**SEVERITY LEVEL III, \$50,000 CP
FLORIDA POWER AND LIGHT COMPANY
ST. LUCIE NUCLEAR PLANT**

**EA 95-180
FLORIDA POWER AND LIGHT COMPANY
ST. LUCIE NUCLEAR PLANT**

**NRC CLOSED PREDECISIONAL
ENFORCEMENT CONFERENCE**

Issues: St. Lucie Power Operated Relief Valves Inoperable

Figure 1

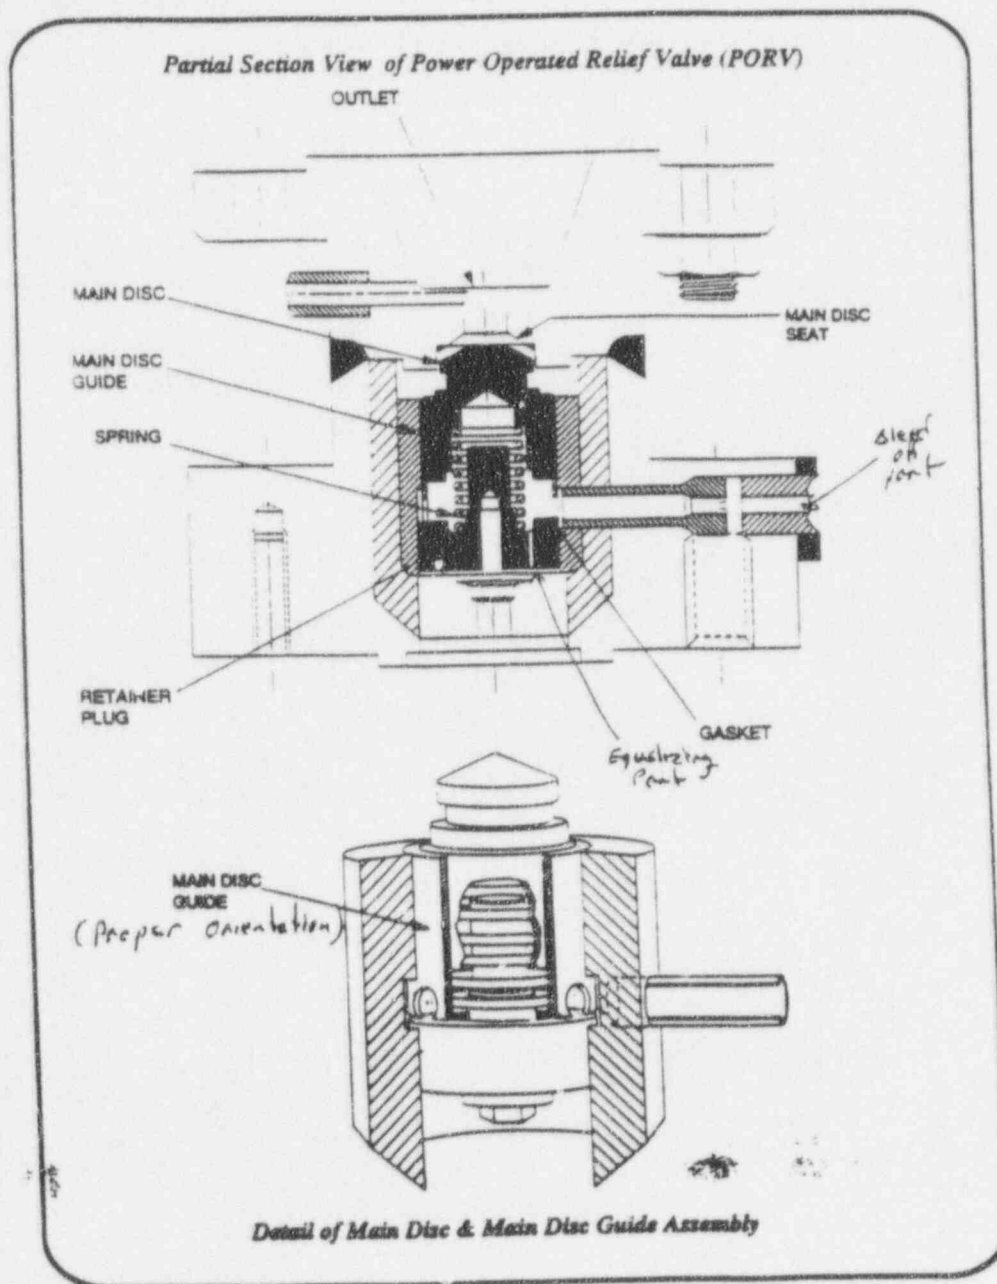
The PORV design in question is a Dresser Industries Model 31533VX-30. The valve is a 2.5" inlet by 4" outlet pilot operated valve with a relief capacity of 153,000 lbm/hr. The internals of the valves are displayed in Figure 1.

The valve, as installed in Unit 1, is actuated by a solenoid valve, which acts on the pilot valve operating lever to open the pilot valve. The open pilot valve creates a vent path from below the main disc of the main valve, through holes machined in the main disc guide, to the quench tank. The reduction in pressure below the main valve main disc allows the disc to move open (down, in Figure 1) under the force of system pressure acting on the main disc.

- Under water pressure at 335 and 450 psig, 10-15 psig was developed at the discharge of the pilot valve, indicating that some leakage around the main disc guide was possible, but not enough to provide venting sufficient to open the PORV.
- Under steam pressure from 50 psig to 450 psig in 50 psig increments, 20-60 psig was developed at the pilot valve discharge.
- Under steam pressure at 2400 psig, 1500-1800 psig was developed at the pilot valve discharge.
